Addendum

Bedroom Slide-out Manual Override

2005 Cheetah

2005 Simba

Main/Wardrobe Slide Room Motor

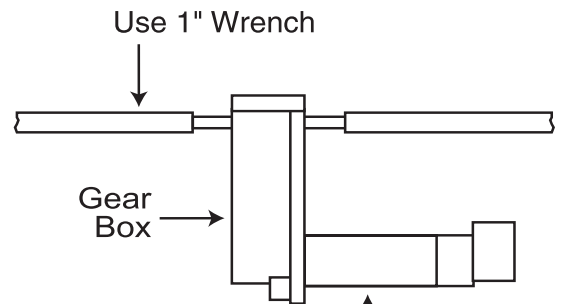
1. The bedroom slide-out motor is located under the bed. Lift the bed and remove the access panel. The main slide and wardrobe motors are located inside the exterior storage bays under the slide-outs.
2. Remove 12 Volt DC from the motor by disconnecting the plug from the slide-out motor to the power supply.
3. Use a 1" wrench (for main and wardrobe slides) or a 3/4" wrench (for the bedroom slide) to turn driveshaft and retract room.
4. Once the slide room has been manually retracted, reconnect power supply. This is necessary to stop the slide room from moving once retracted.
5. Take the motorhome to an authorized repair center.
